## Planning Commission Staff Report

**Petition:** P.Z. 15-2009 Chesterfield Airport Commerce Park (Insituform Technologies Inc.)

**RE: P.Z. 15-2009 Chesterfield Airport Commerce Park (Insituform Technologies Inc.)**

Re: Insituform - Chesterfield Airport Commerce Park  
Responses to 12-21-2009 comment letter  
(Stock Project No. 209-4488)

CHESTERFIELD AIRPORT COMMERCE PARK  
PRELIMINARY PLAN

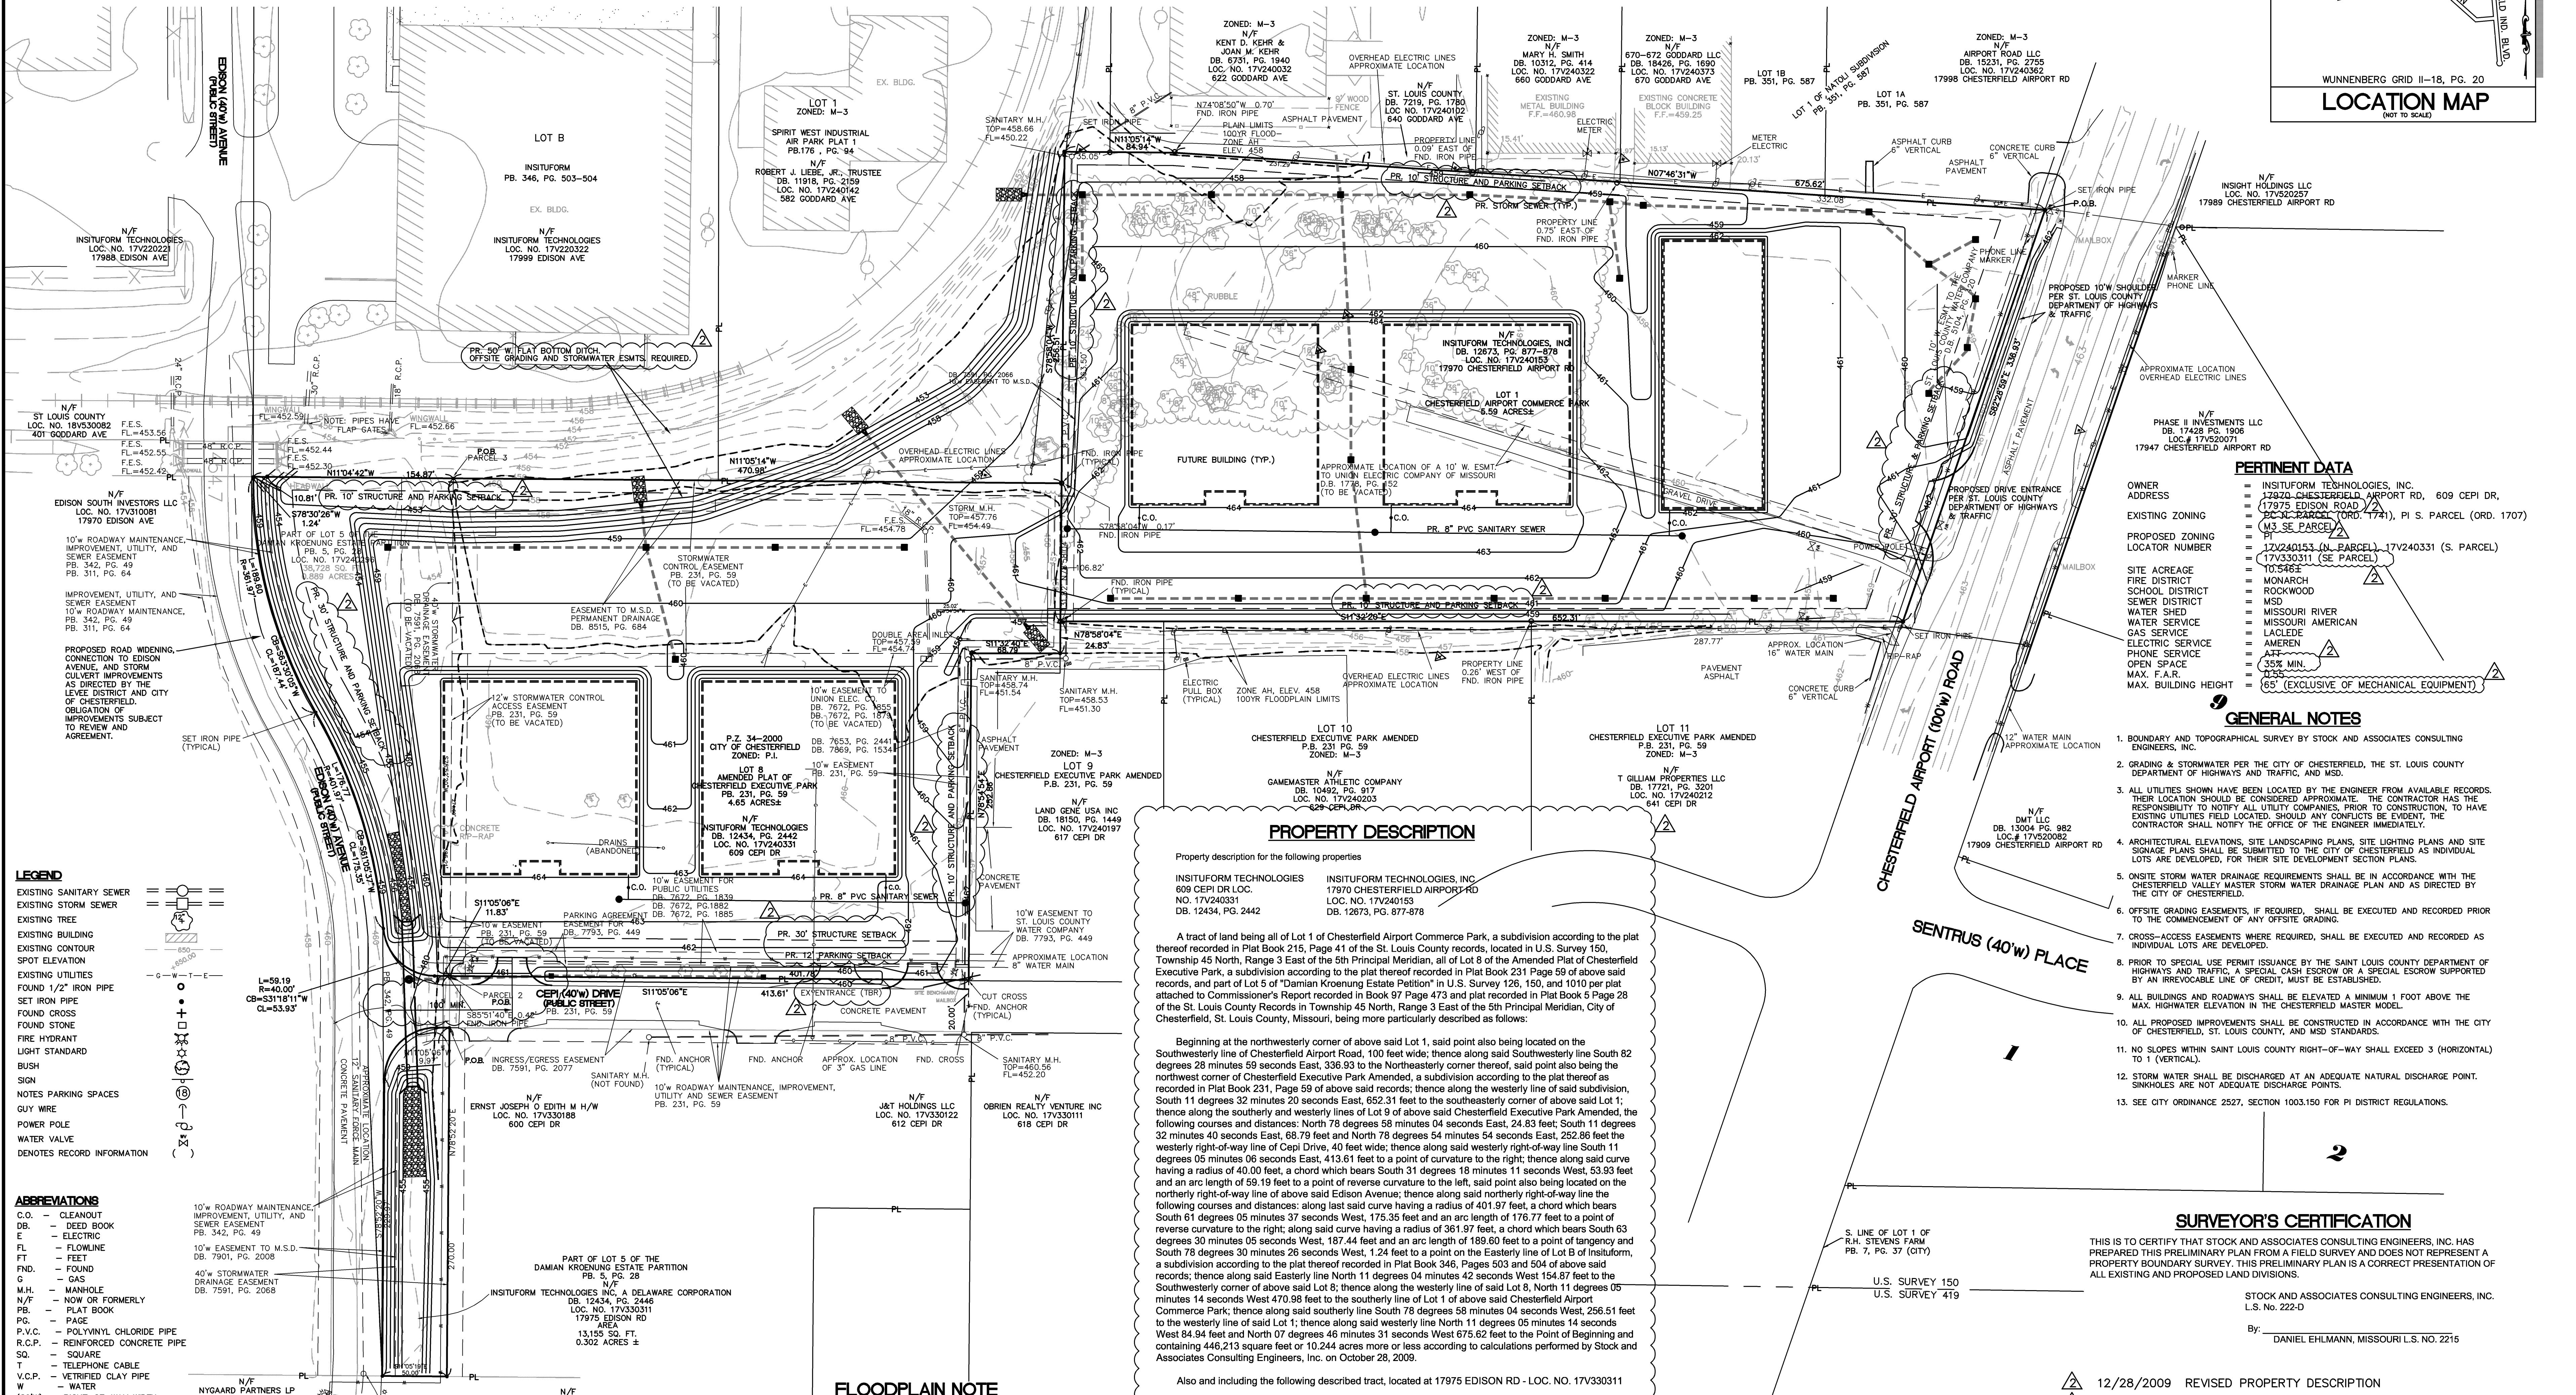
1. The petitioner was asked to revise the Preliminary Plan so that the access point(s) along Cepi Drive comply with the City of Chesterfield Access Management requirements. The petitioner has moved the centerline of the proposed southern most entrance to 100’ off the proposed Edison Avenue ‘edge of pavement’. Additionally, they have identified the existing driveway to be removed. Staff is still reviewing the plan to determine compliance with the City of Chesterfield Access Management requirements.

1. Revise the Preliminary Plan to show the proposed access point(s) to 609 Cepi Drive that complies with the City of Chesterfield Access Management requirements.
2. How does the list of requested uses compare to the list of approved uses for the adjacent districts?
3. How do the proposed uses fit with the City of Chesterfield Comprehensive Plan Service/Business Park Land Use Designation? Provide an amended list of requested permitted uses.
4. Consider restricting certain uses to each parcel based on its appropriateness fronting Chesterfield Airport Road and Edison Avenue.
5. What are the proposed hours of operation?
6. What is the proposed maximum building height?

1. The preliminary plan depicts two entrances onto Cepi Drive that do not comply with the Access management Standards as defined in Chapter 26 of the City Code.
2. There is a third entrance which is the existing curb cut that may not be allowed and all future plans should clearly define this entrance as existing and will be removed.

**Response:** The centerline of the proposed southernmost entrance is shown to be 100' minimum from the proposed Edison 'edge of pavement' lane.
